Representations for Mr and Mrs M. Beavis (Beavis Family) ref - A38DJ-AFP070/1

Application by Highways England for an Order Granting Development Consent for A38 Derby Junctions Project.

<u>Further Submissions by Mr. and Mrs. M. J. Beavis (The Beavis Family).</u> <u>references:- A38DJ-AFP070/1 - Further Ref:- 20022809.</u>

<u>The basis for our Representation – re:- closure/diversion of the Footpath</u> at the newly proposed Little Eaton A38 Flyover

Plan showing the present Public Footpath arrangements from Breadsall to the area around and to the Little Eaton Island on the A38 Trunk Road. Ref no:- A38DJ-AFP070/1. Further ref:- 20022809

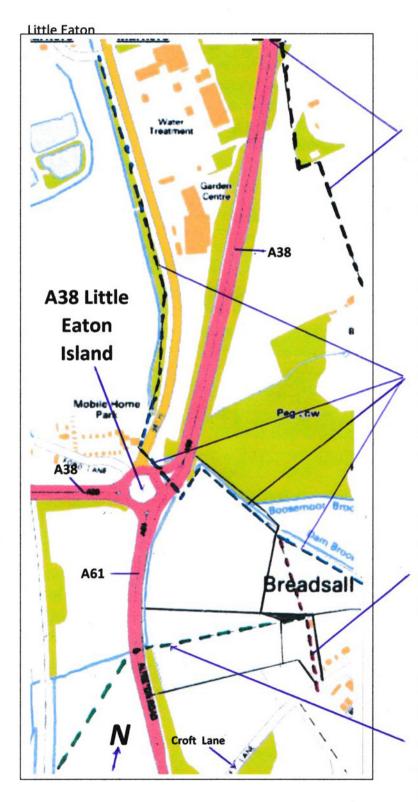
The proposal by Highways England (H.E.) to close and divert Footpath No. 3 from Rectory Lane and Croft Lane to the Little Eaton A38/A61 Island flyover and onto Little Eaton fails to retain this long established route. This is specifically signed on Croft Lane. Furthermore, the proposed diversion returns the pedestrian south (in the wrong and opposite direction), adjacent to A61, to join F.P. No. 1 on its route to Darley Abbey. Such a route would mean it necessary to cross the dual carriageway of the A61 at some point, which is fast moving, with no provision for the pedestrian to cross and then return some distance north, to encounter the complex new fly-over and road pattern at the Little Eaton A38 flyover, on their route to Little Eaton. A footpath should provide a direct route between two places.

It seems illogical to expect walkers to travel south for about a quarter of a mile, along the proposed new route, adjacent to the A61, to then have to return a similar distance north. Obviously the footpath, currently at the A38 Island, should be routed north (on the Breadsall side), alongside the eastern side of the newly positioned A38, to meet up with Bridle Path No.18, adjacent to the Severn Trent Water Works, using the existing underpass, to safely arrive in Little Eaton. No major road would have to be crossed and the original purpose of the F.P. achieved.

In addition, please can we ensure that the Alder trees etc. along our boundary with the A61,(adjoining F.P. No. 1), be retained to help reduce pollution for grazing animals and crops grown to feed animals.
